2014 - 2018 Corvette: Service Bulletin: #PIP5248D: Stalling Shudder And/or Hard shifting Into 1st Gear Or Reverse Vibration On launch

#PIP5248D: Stalling Shudder And/or Hard shifting Into 1st Gear Or Reverse Vibration On launch (With Excessive Crankshaft End Play) - (Aug 10, 2017)

This PI was superseded to update Models. Please discard PIP5248C.

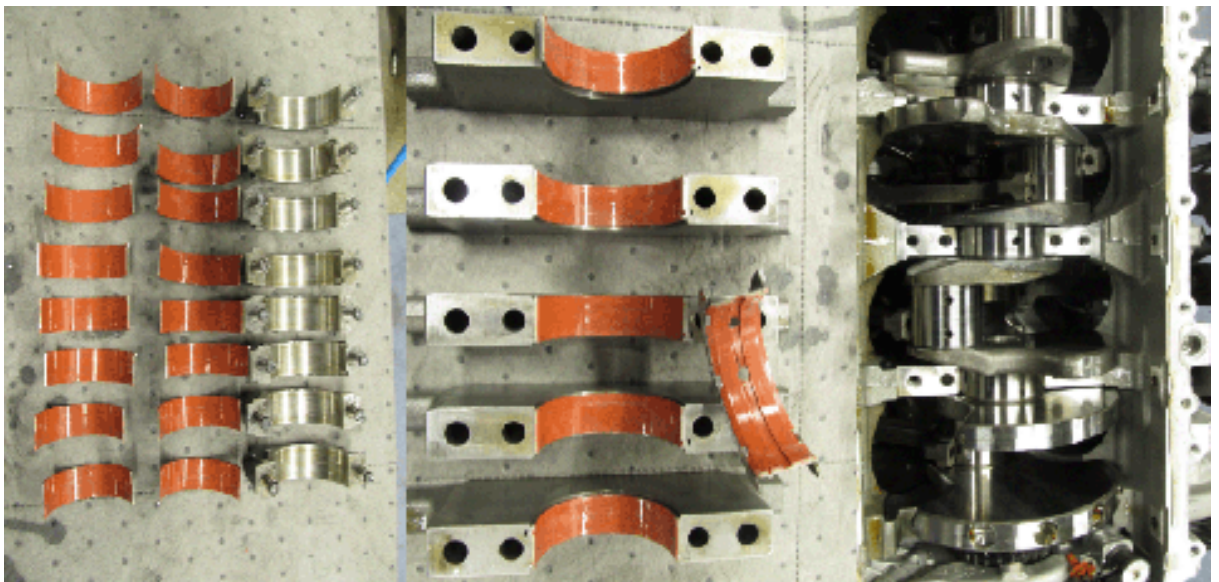
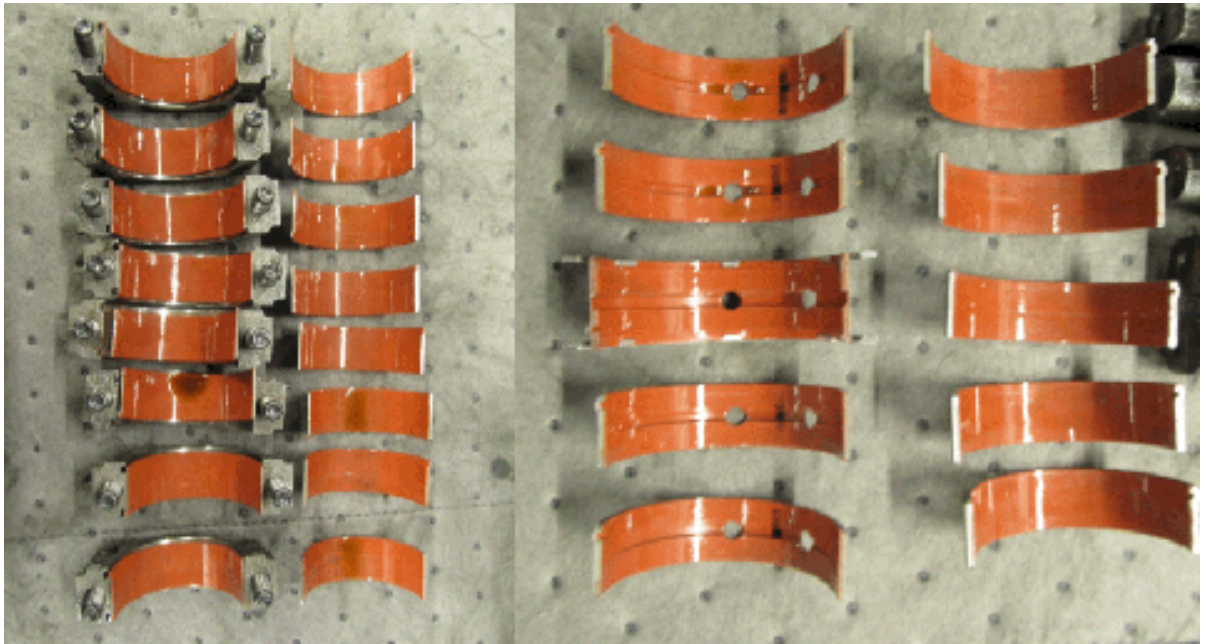
If end play is found to be out of specification, remove engine and inspect for possible Crankshaft thrust bearing and/or crankshaft for wear.

Note: If bearings and crankshaft look like components in attached picture, damage has not occurred.

Inspect thrust bearing for wear on one side and crankshaft on that “mating” surface.

If wear is evident (3 vertical channels worn off) replace connecting rod bearings, main bearings, thrust bearing and crankshaft.
